Project: IEEE P802.15 Working Group for Wireless Personal Area Networks (WPANs)

Submission Title: [Resolutions for the new comments received before May 9]

Resolutions for the new comments received before May 9

Figure 189

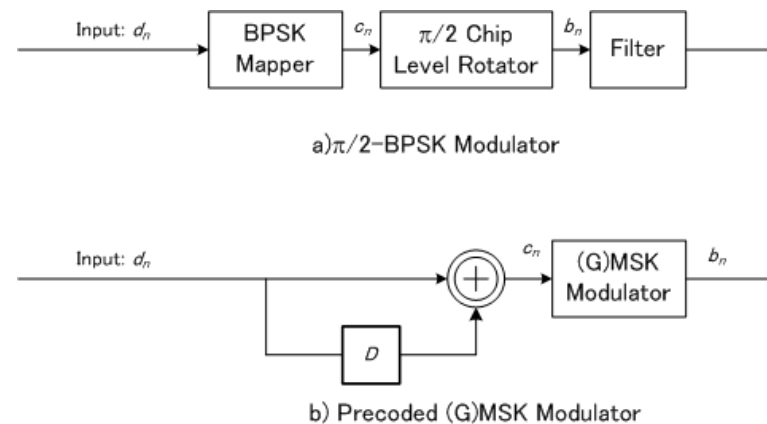
- Figure 189, more description in terms of equations is required to equate $\pi/2$ BPSK modulator and GMSK modulator. For example initial phase of the chip level rotator. Also, the differential operation (xor) as currently specified is incorrect. If g_n is the input to the GMSK modulator then in the real field $g_n = d_n \times d_{(n-1)}$ which is inverse of xor. In general, complete specification through equations would help rule out ambiguity
- Resolution: Accept the comment partially. Equations shown in the next slide shall be added to equate $\pi/2$ BPSK modulator and GMSK modulator. Figure 189 shall be replaced as shown in the next slide.

To be modified
